Test Report 8184347.

Autoflame Eng Ltd

Mk7 M.M. electronic fuel/air ratio control with integrated burner control.

Document review and limited testing of Mk7 M.M. software and hardware changes for continued compliance to BS EN 298:2003 Automatic gas burner control systems for gas burners and gas burning appliances with or without fans.

Board 7012 has changed from version Rev 1a to Rev 2a:

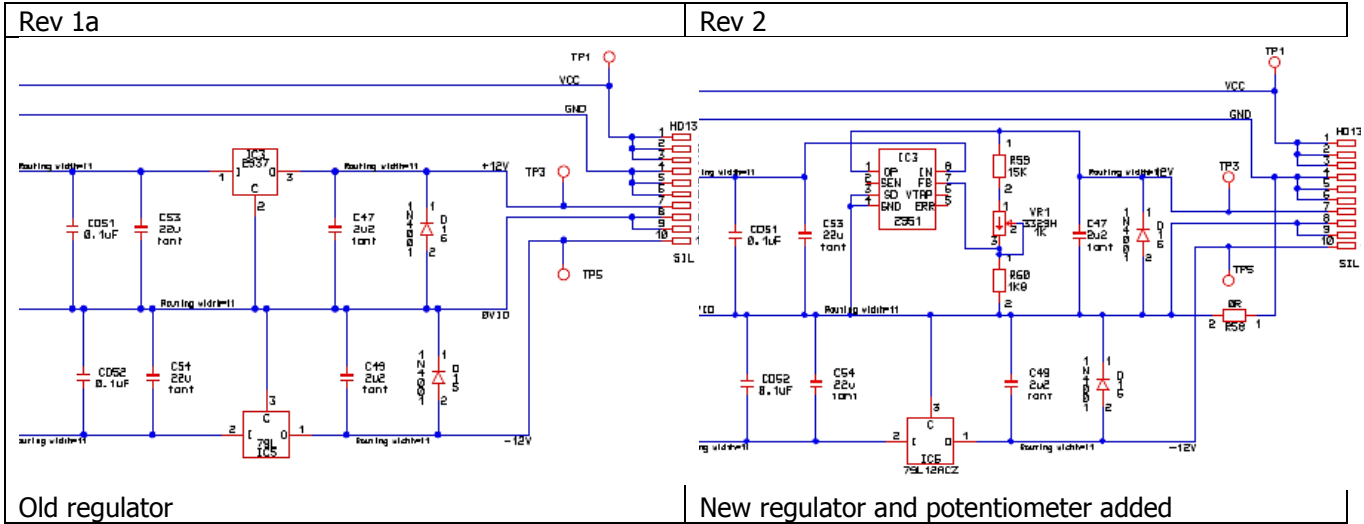
Version	Changes made
Rev 2	+12V regulator changed from 2937 to 2951 and adjustment potentiometer added
Rev 2a	UV shutter changed to be supplied directly from 15V supply.

See below for detail of the change made for board Rev 2.

The change of Rev 2a is to overcome an issue with the UV flame scanner self-check. The UV shutter motor is rated from 12-15 V but the original design running at 12 V was found to be too low on some UV shutters resulting in occasional no operation, leading to nuisance lockouts.

The above changes to boards 7012 and 7013 have no impact to the safeguarding and safety critical functions of the hardware, with the exception of the change of 7012 Rev 2a which improves the operation of the UV self-check function.
